Derby Tidal Power Project

Derby Hydro Power Pty Ltd

**Report and Recommendations
of the Environmental Protection Authority**

**Environmental Protection Authority
Perth, Western Australia
Bulletin 942
June 1999**

Figure 4. Tidal power station redesign.

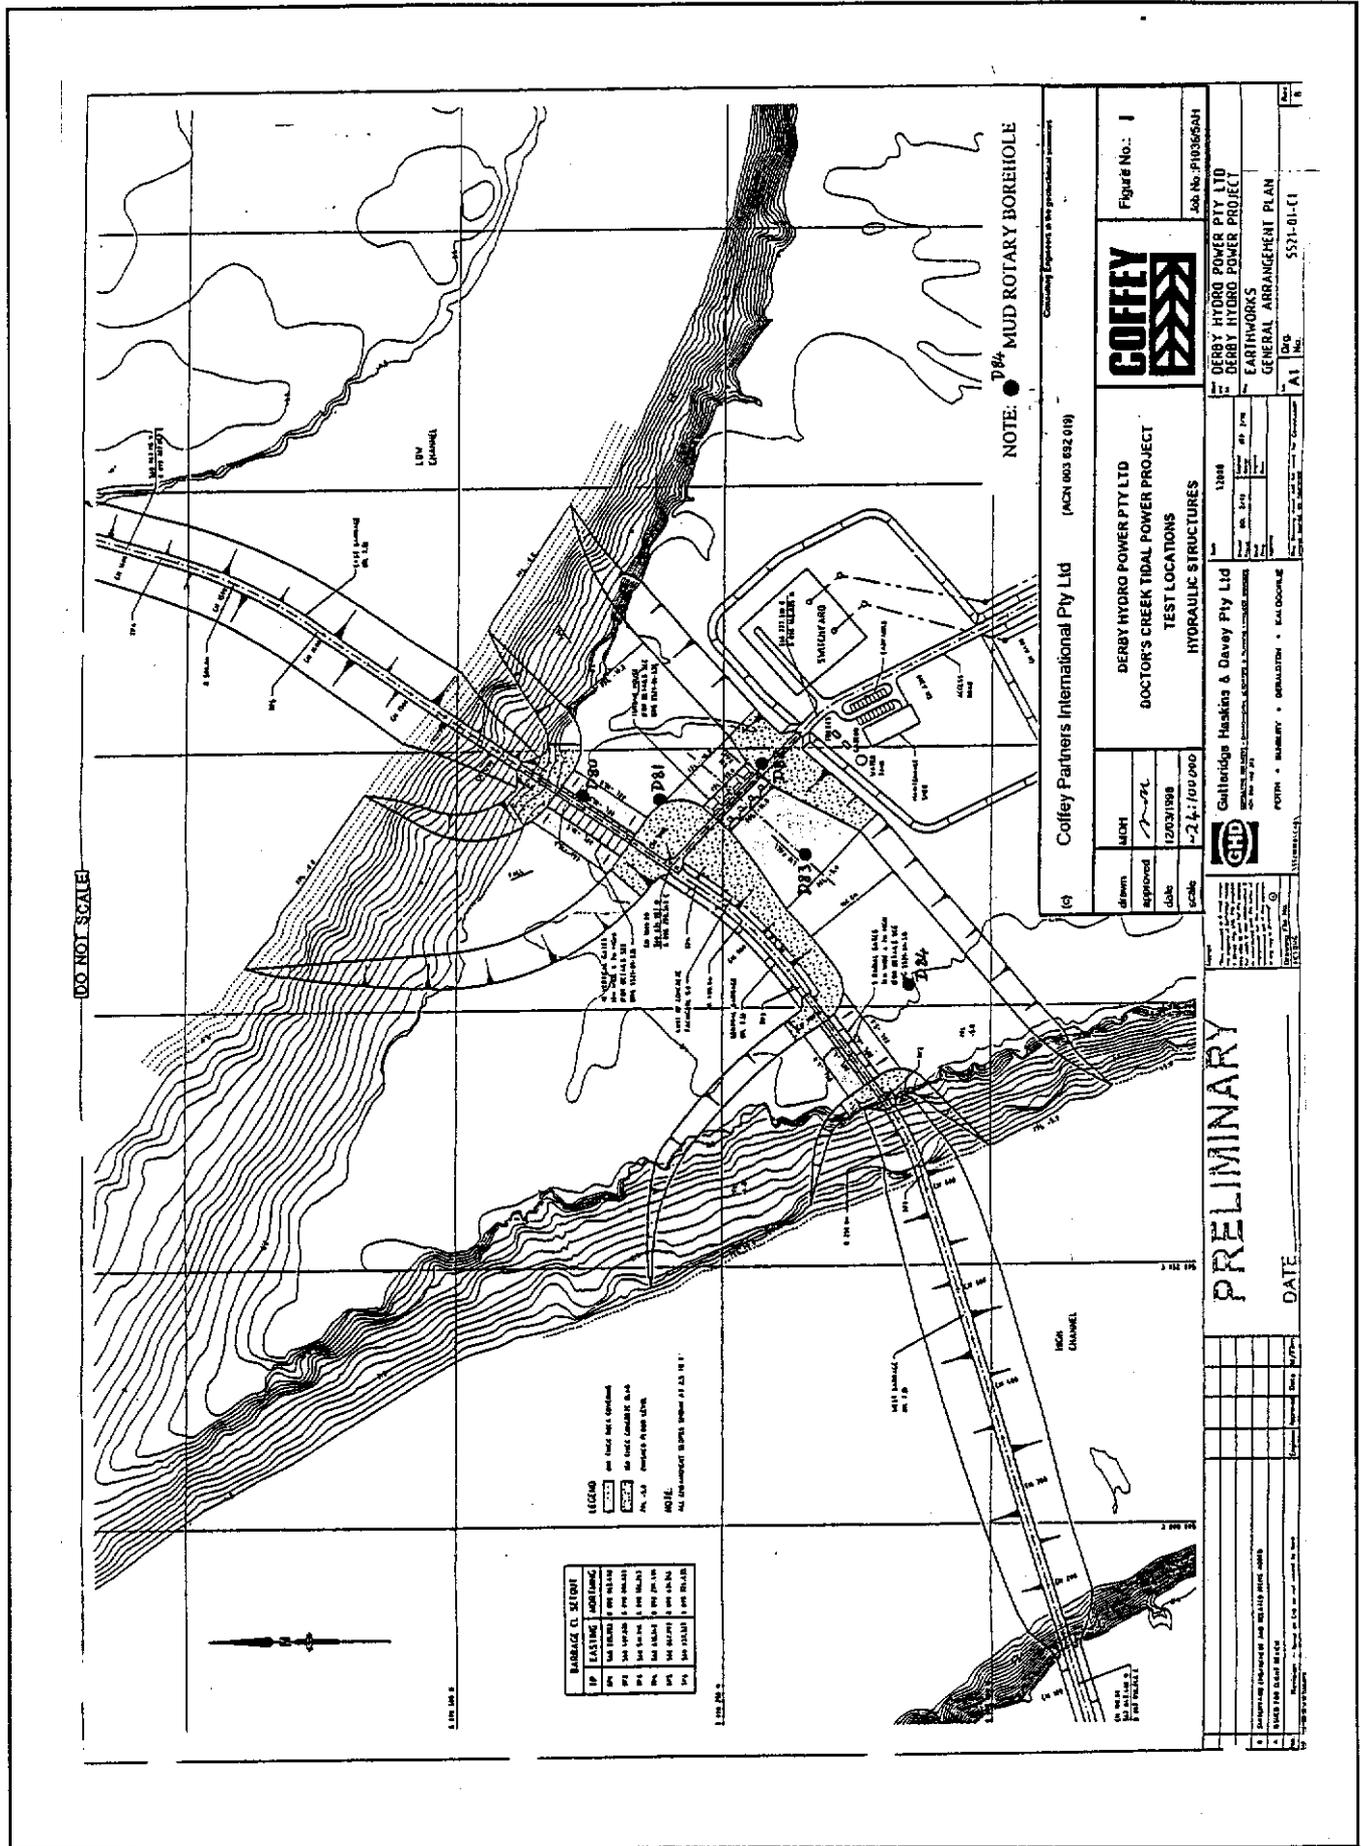
Since release of the CER a number of modifications to the proposal have been made by the proponent. Refer to Figure 4 for the re-designed structure. The changes include:

- barrages across East and West Doctors Creek cover the entire length of the mouths of both creeks; and
- channels dug on the peninsula between the two creeks in which the sluice gates will be placed.

Figure 5. Location of proposed nature reserve.

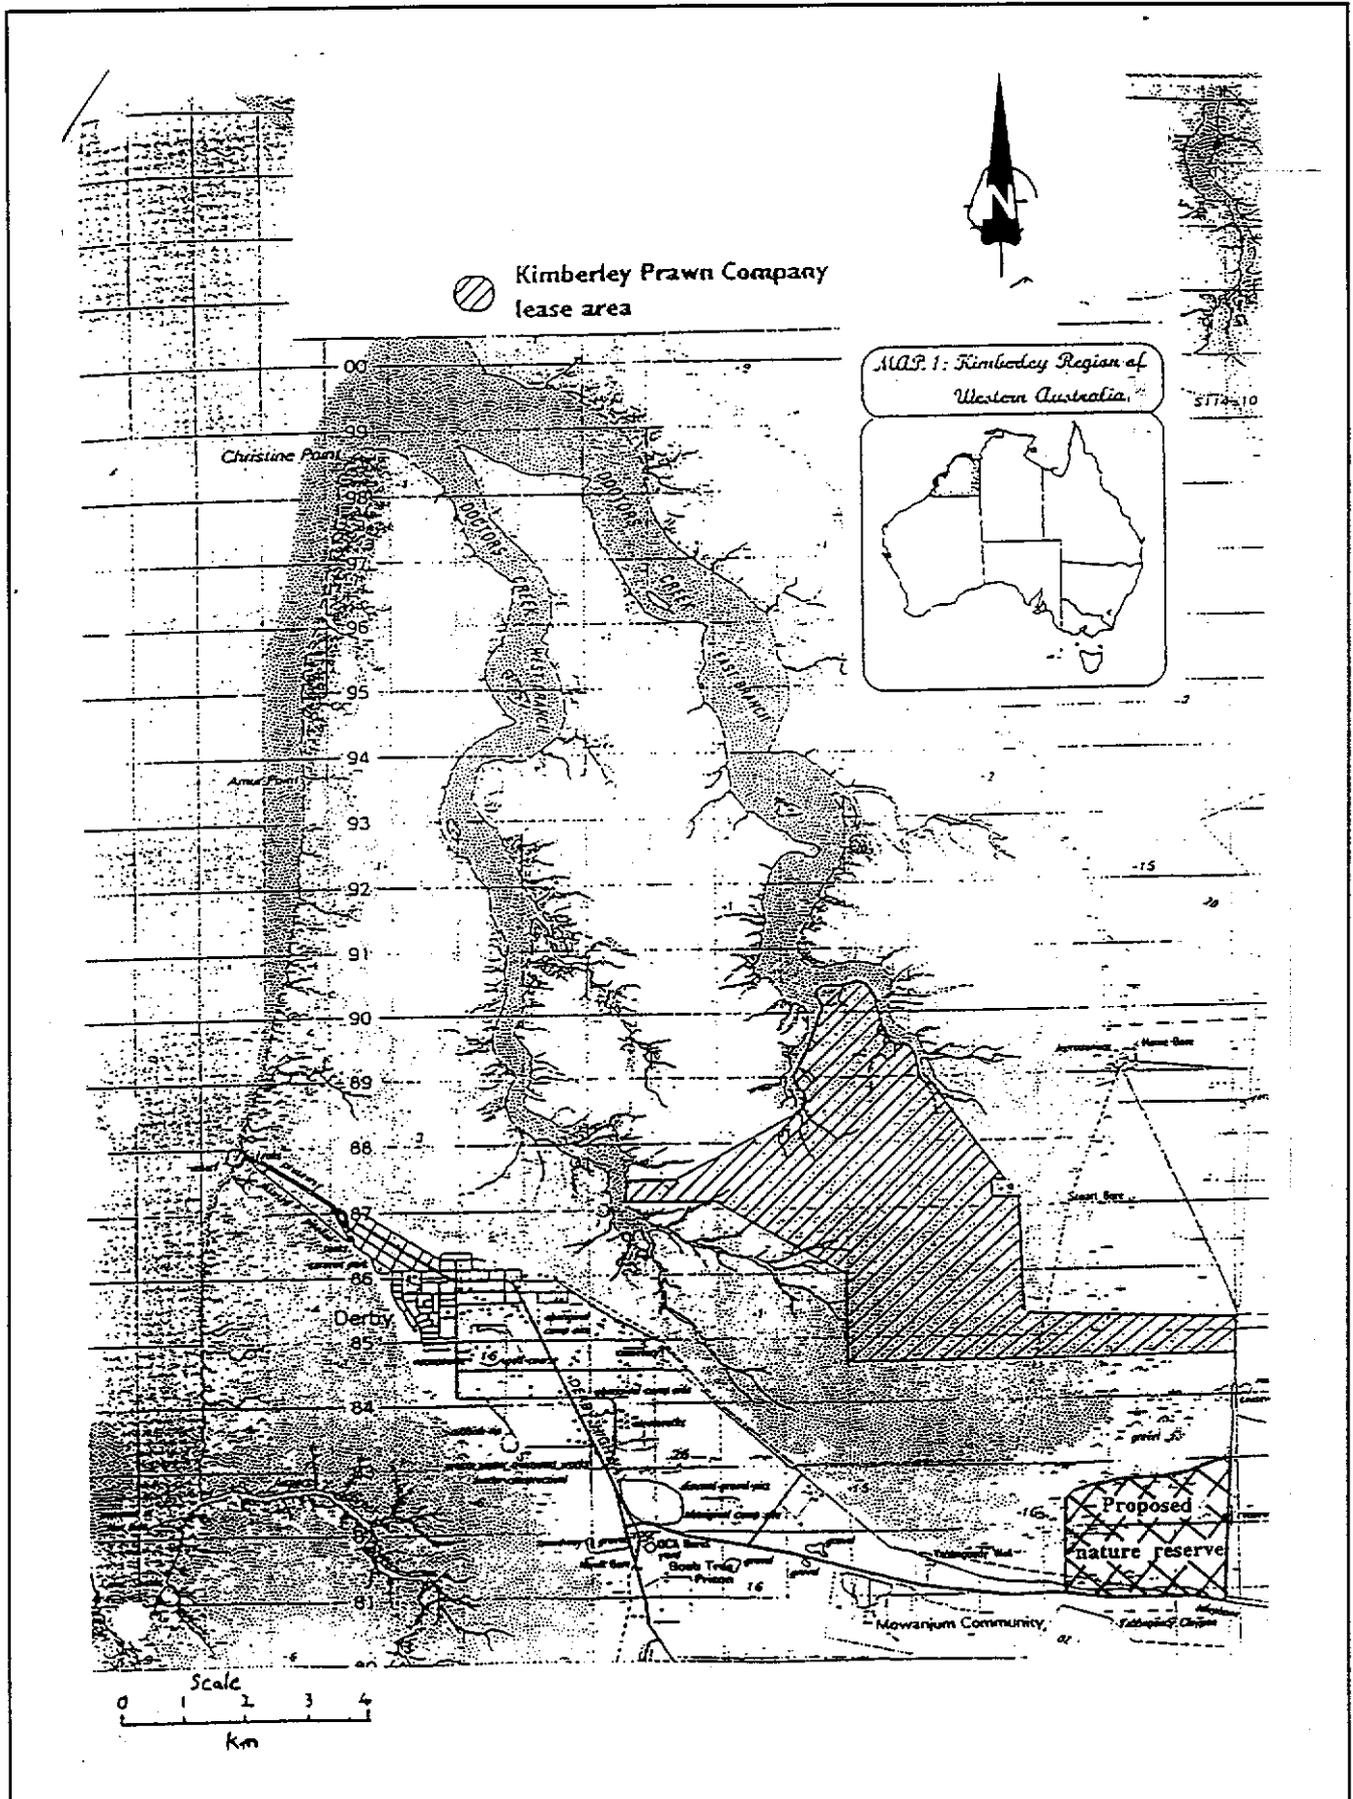
A nature reserve is proposed for an area to the south east of the mudflats of Doctors Creek on Lots 263 and 87 (Figure 5). The proposed nature reserve has the objective of protecting within the conservation estate the vegetation communities of an area of land that is representative of the mudflats, remnant Pleistocene pindan (red sand) dunes and sub-coastal black-soil plain of the south-west Kimberley. The area supports mixed woodland of Melaleuca, Eucalyptus and Boab trees, scattered shrubs and some samphire (Burbidge, 1982).

The lower margins of the proposed nature reserve are subject to inundation 6 to 12 times per year on high spring tides. The construction of the tidal power station would alter the mean tidal height in both creeks and reduce the maximum tidal height reached on spring tides, affecting the inundation patterns at the most easterly part of the mudflats. The altered hydrology of the creeks may also change the groundwater salinity near the margins of the mudflats, potentially affecting the fringing vegetation.

To ensure the protection of a representative portion of this type of community the proponent would be required to establish a monitoring program that detects any changes in the vegetation structure or health. If such a change is detected then the proponent would be required to identify an alternate comparable area of land in consultation with CALM, acquire this land and make it available for CALM for reservation within the conservation estate. CALM has indicated that similar parcels of land exist in the area and that it would be willing to consider such an arrangement. This would ensure that the environmental values of the area are protected within the conservation estate.
